Service Information Bulletin

****Technical Campaign****

Subject: Threaded fasteners, handlebar clamping block

Model: F 800 GT (K71/11)

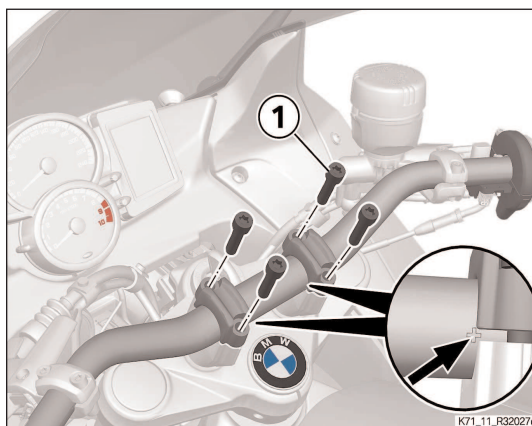
Details: Within the framework of quality monitoring, BMW Motorrad has ascertained that the wrong screws were used for the handlebar clamping blocks on a small number of vehicles (approx. 48 in the US). If these threaded fasteners are re-installed in the course of repair work or a retrofit, there is a possibility of the threads in the tapped holes of the clamping blocks being damaged.

Aftersales Solution: Screws (1) of all the motorcycles affected have to be replaced before customers take delivery; the procedure is analogous to that described in work item 32 71 040 "Replacing handlebars". See the description of the work item on the current RSD (Repair and Service Data BMW Motorrad) DVD.

Part number: 07 12 9 907 080 M8 x 30 screw (x4)
